TRUCK, SURVEILLANCE, LIGHTWEIGHT, WINCH, MC2 - LAND ROVER 110
FITTING OF ROLL OVER PROTECTION AND HEAD RESTRAINTS

MODIFICATION INSTRUCTION

FIG 1 - ROLL TUBE REAR VIEW (REAR BRACES NOT SHOWN)

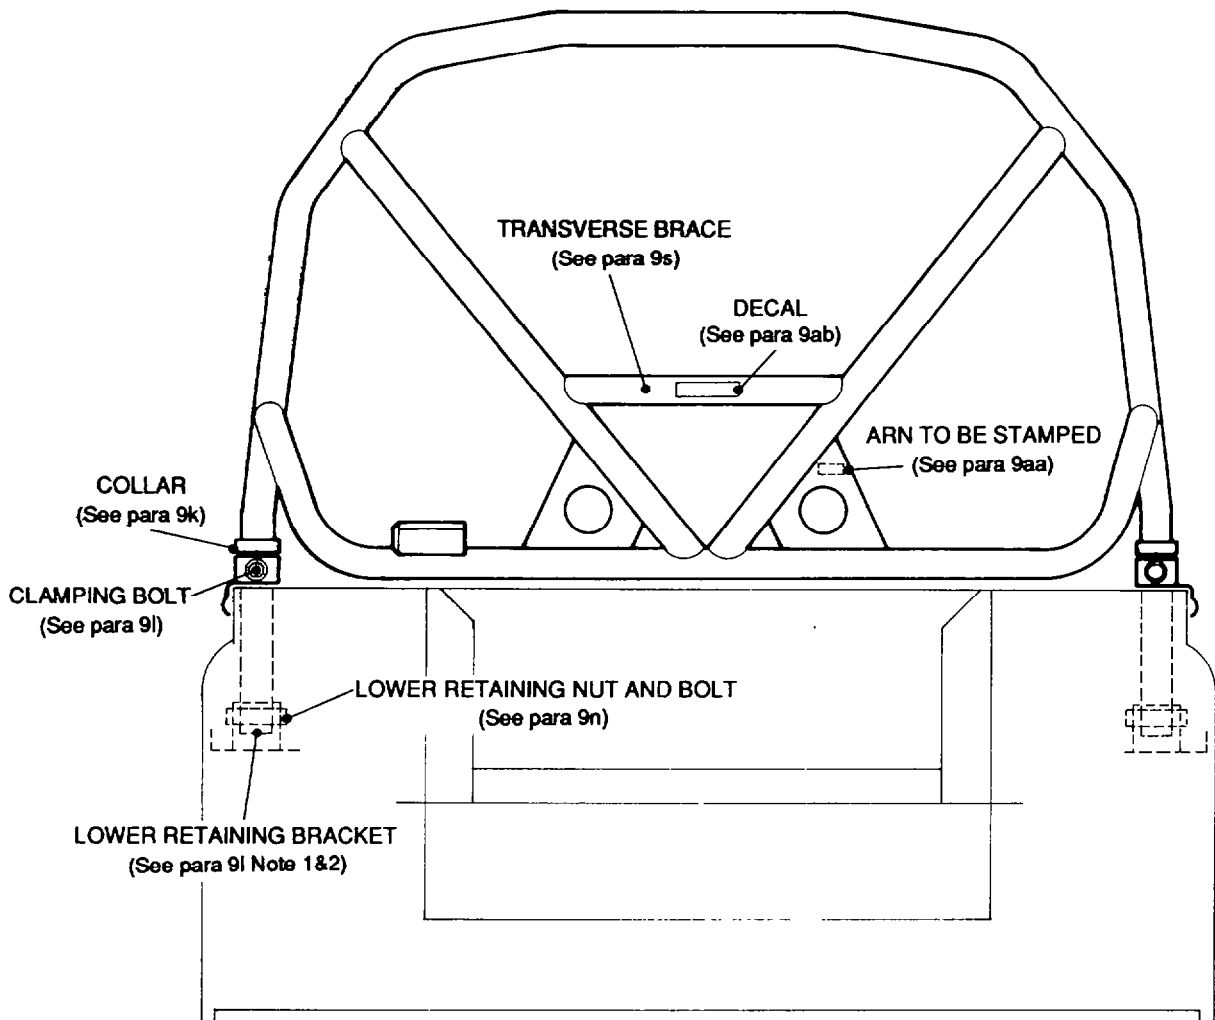
- j. Grind the welds and remove the auxiliary power socket bulkhead brackets from the bulkhead and the spare wheel mounting brace brackets from the body side cappings.
- k. Slide the collars (item 1b from Table 1) onto the new roll bar assembly (item 1a from Table 1), as shown in Fig 1.
- l. Fit the new roll bar assembly to the vehicle and fit the clamping bolts (item 1g from Table 1) as shown in Fig 1.

1. Ensure that the legs of the roll tube assembly are properly located in the lower retaining bracket.
 2. If difficulty is experienced when locating the roll tube assembly during the fitment, then contact MEA, B Vehicle section, on (03) 282 6663.
- m. Refit the cam net carrier and the horizontal canopy rails to assist in the location of roll tube and to ensure correct fitting location of the cam net carrier on completion.
 - n. Drill the lower roll tube retaining brackets to allow the fitment of the lower retaining bolts, nuts and washers (items 1h, 1i and 1j from Table 1), as shown in Fig 1.

- 1. Fit the spare wheels to ensure that there is clearance between the bulkhead and the stowage bins and then remove them from the vehicle.
- s. Position the transverse brace (item 1e from Table 1) in the vee of the roll tube assembly braces, as shown in Fig 1, mark and grind the contact area and then tack weld the brace in position.

- aa. Using 6 mm metal stamps, clearly mark the vehicle ARN on the front and rear of the gusset as shown in Fig 1.
- ab. Fit the warning decal (item 1n from Table 1) as shown in Fig 1.
- ac. Refit the spare wheels and the rear seat assembly.
- ad. Replace the seat belts on the upper mounting position of the roll tube and return the seats to the upright position.
- ae. Refit the horizontal canopy rails, canopy, cam net carrier and boat racks.
- af. Refit the battery connections.

FIG 2 - WELD DIMENSIONS LOWER CAPPING PLATE

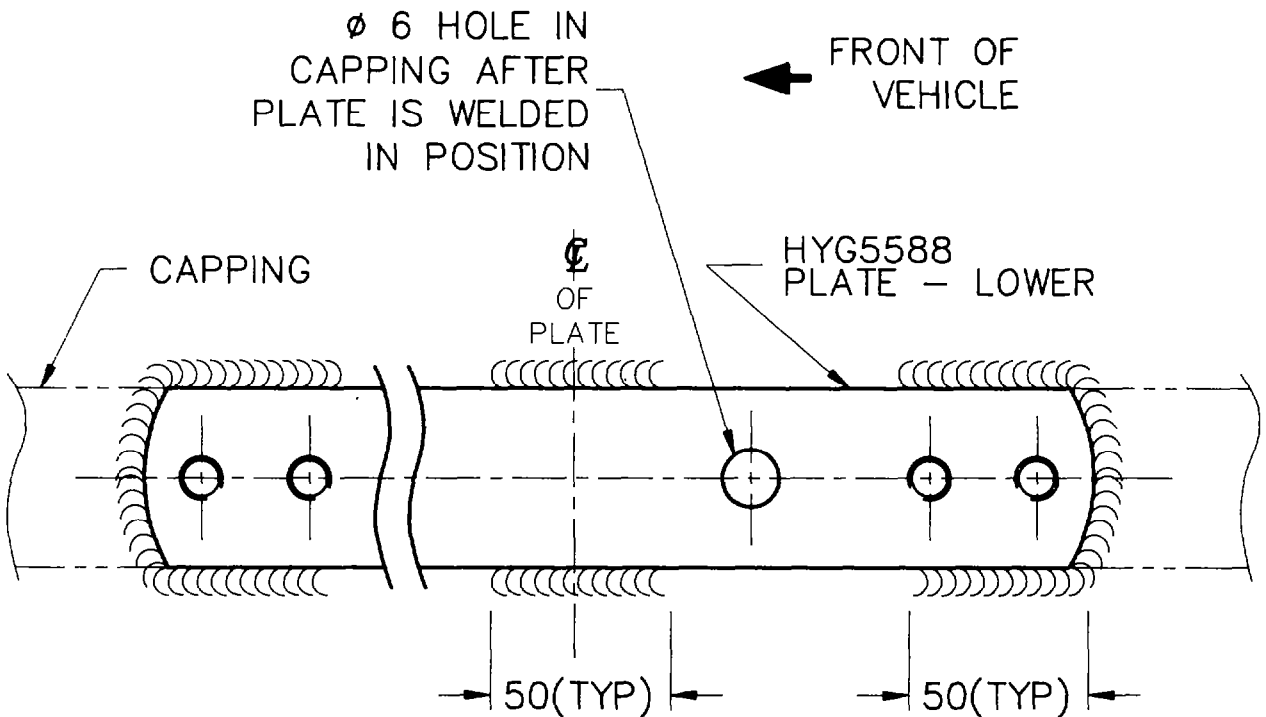
- 1. Ensure that the collars contact the upper roll tube retaining bracket before welding.
- u. Fully weld the threaded capping plate to the body capping, as shown in Fig 2.
- v. Fully weld the transverse and rear braces to the roll tube.
- w. Remove the cam net carrier, horizontal canopy bows and roll-tube mounting bolts and raise the ROPS assembly to complete the welds on the lower edges of the roll tube assembly.
- x. Lower the ROPS assembly and refit all mounting bolts after applying Loctite 277 to the threads.
- y. Clean all welds and paint all exposed surfaces with primer, zinc rich epoxy and allow to dry, then apply brown paint (item 4 from Table 1) as a finish coat.
- z. Fit the auxiliary power socket bracket (item 1q from Table 1) and wiring to the bracket on the roll tube.

FIG 3 - FITTING OF HEAD RESTRAINTS

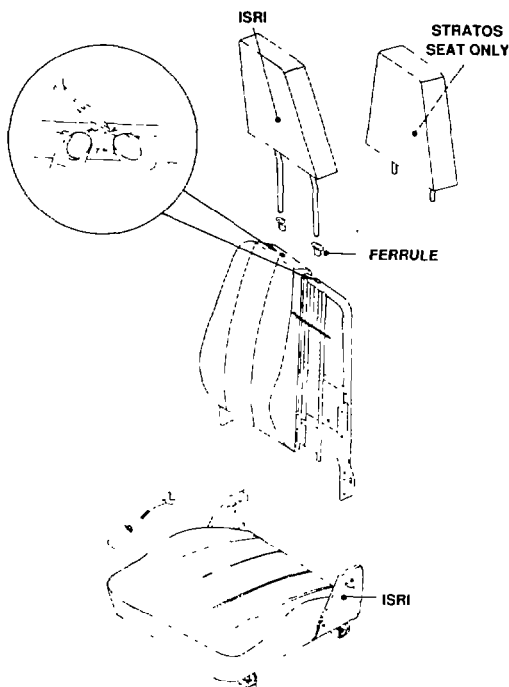
- a. Locate the vertical tubes located beneath the vinyl trim in the seat back and cut the vinyl with a sharp instrument to expose the apertures, as shown in Fig 3.
- b. Fit the restraints (item 1p from Table 1) into the tubes until they are flush with the seat squab.
